UNITED STATES
NUCLEAR REGULATORY COMMISSION

APPLICANT: Westinghouse Electric Corporation
PROJECT: AP600
SUBJECT: SUMMARY OF MEETING TO DISCUSS AP600 APPLICATION OF WCOBRA/TRAC FOR LONG TERM COOLING ANALYSES

Figure 440.554-1 Long Term Cooling Calculation Code Stream

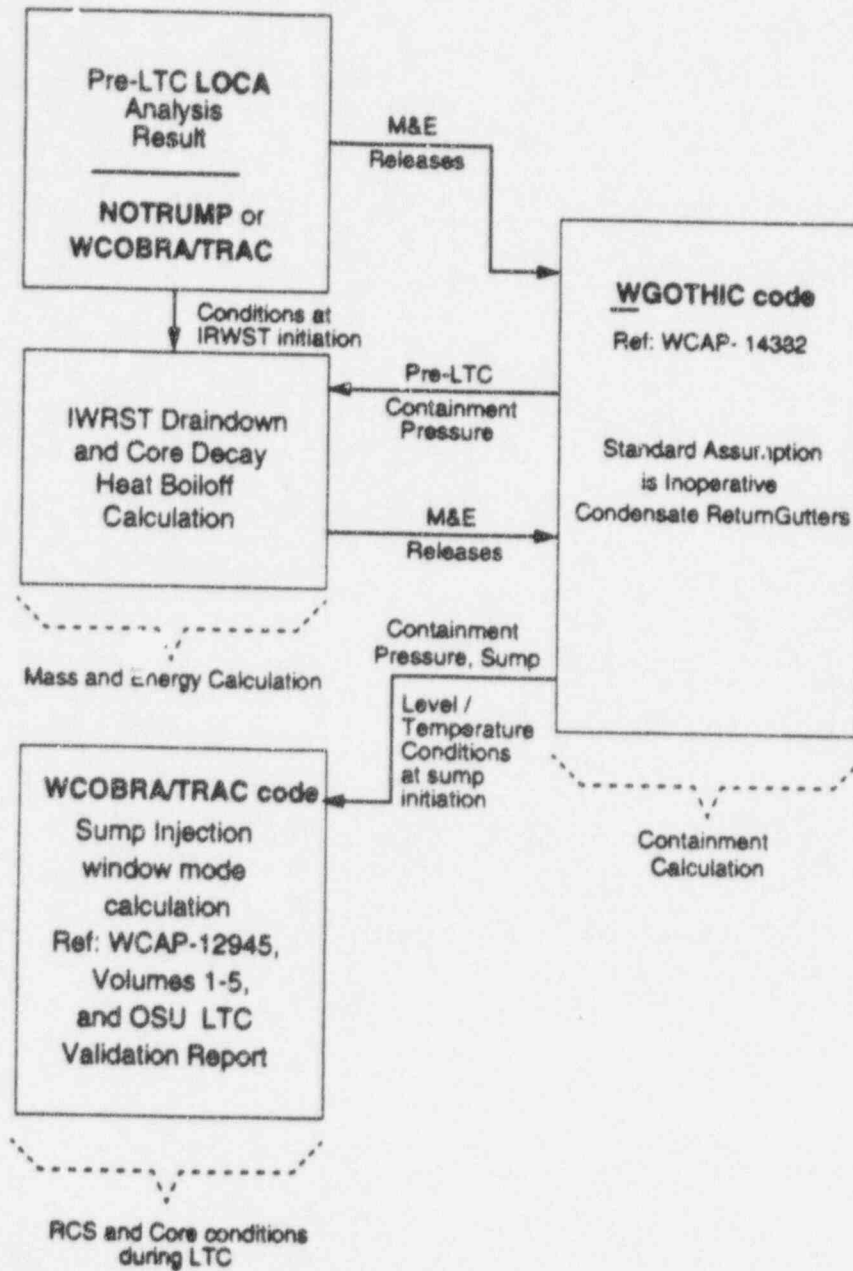
- How the GOTHIC code is relied upon to establish containment conditions for the long term cooling boundary conditions, such as containment pressure and sump levels, and exactly how the thermal-hydraulics of the reactor coolant system have been decoupled from the containment analysis. In addition, it was unclear if the in-containment refueling water storage tank drain-down and switchover to the sump (recirculation) cooling mode was performed with NOTRUMP, WCOBRA/TRAC, or GOTHIC.
